**PLANNED UNIT DEVELOPMENT &
SUBDIVISION STAFF REPORT**

DEVELOPMENT NAME West Hill LLC (Tom Carwie, Agent)

SUBDIVISION NAME West Hill Subdivision

LOCATION West terminus of Hilltop Drive South

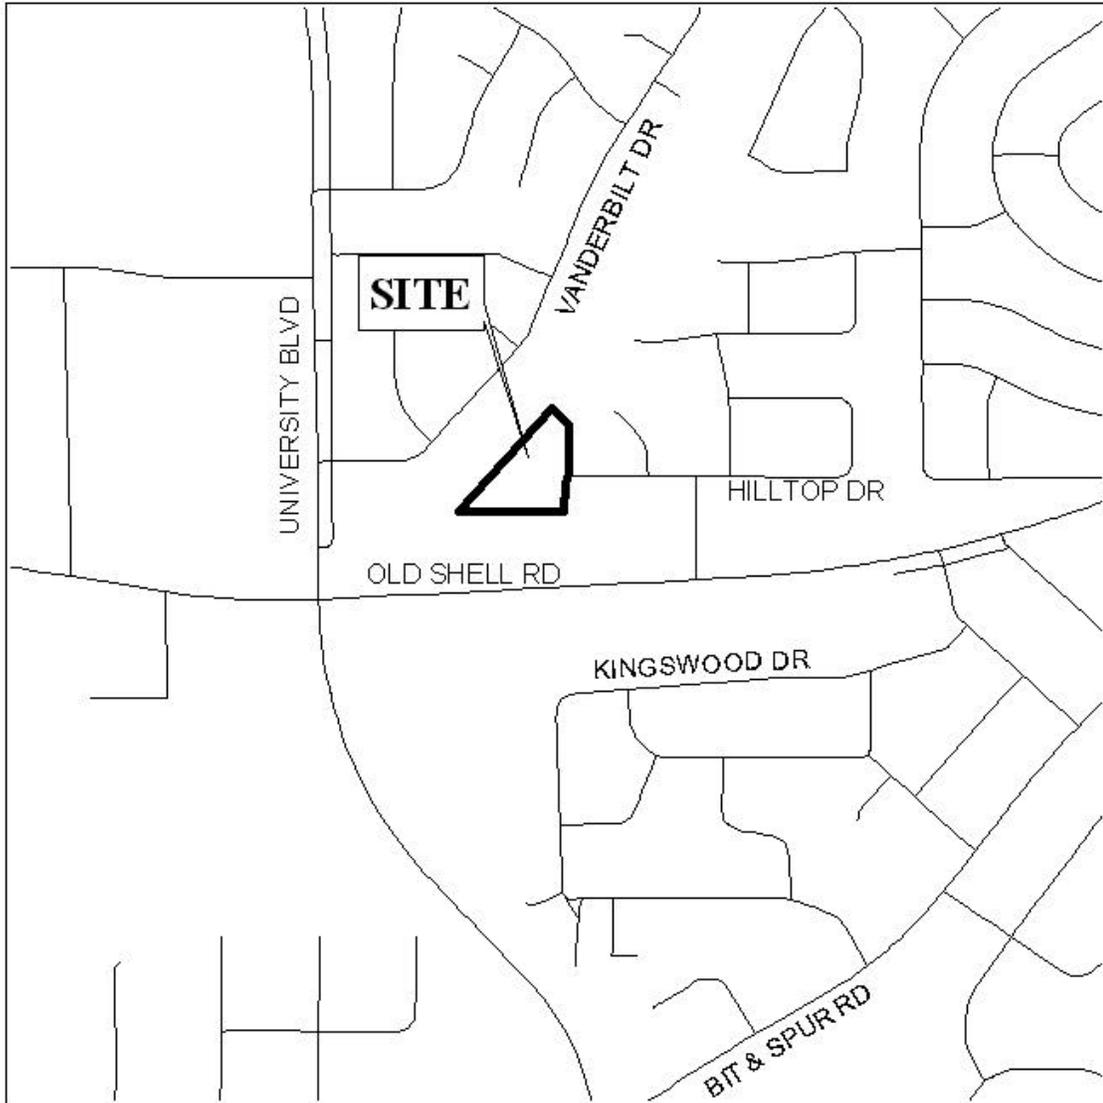
Site coverage is calculated for each individual lot, and as proposed up to 55% of each lot could be covered with a building footprint. It should be noted that only the footprints of the building structures are used to calculate site coverage; the impervious area of the lots (such as driveways, patios and sidewalks) are not included in the site coverage calculations, thus the impervious area of each lot would actually exceed 55 percent.

SITE PLAN

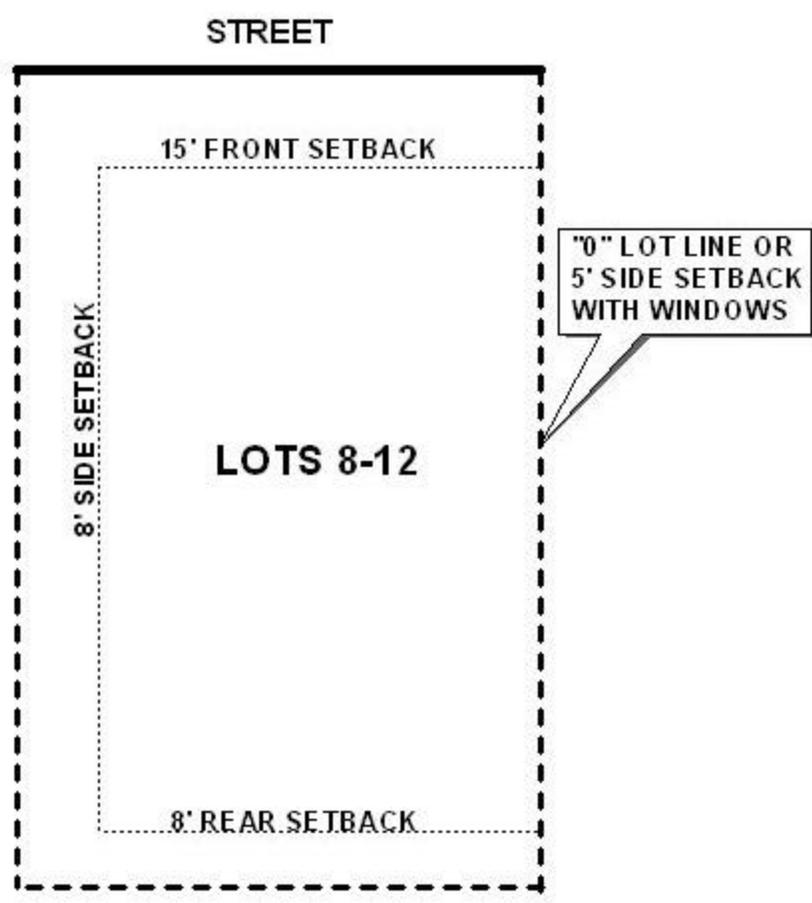
As illustrated on the plat, there is a large 60-inch diameter live oak located on the site; this tree should be preserved, and any work within the canopy of the tree should be coordinated with and approved by Urban Forestry. It should also be noted that this was a condition of the previous approvals.

While Lots 1-5 contain less than 7200 square feet in area, the overall density of the site, exclusive of the street and detention area, complies with R-1 density requirements.

RECOMMENDATION **Planned Unit Development:** Based upon the preceding, it is recommended that this application be approved for **45%** site coverage, with reduced lot widths, lot sizes, and building setbacks subject to the following conditions: 1) maximum site coverage of 45% per lot; 2) reduced setbacks as shown on the plat submitted; 2) preservation of the 60-inch live oak on Lot 1, and any work within the canopy of the tree to be coordinated with and approved by Urban Forestry; 3) dedication and construction of the street to City standards; and 4) full compliance with all municipal codes and ordinances.

Subdivision: With modifications, the plat will meet the minimum requirements of the Subdivision Regulations and is recommended for Tentative Approval subject to the following conditions: 1) maximum site coverage of 45% per lot; 2) reduced setbacks as shown on the plat submitted; 2) placement of a note on the final plat stating that the 60-inch live oak on Lot 1 is preserved, and any work within the canopy of the tree must be coordinated with and approved by Urban Forestry; 3) dedication and construction of the street to City standards; and 4) full compliance with all municipal codes and ordinances.
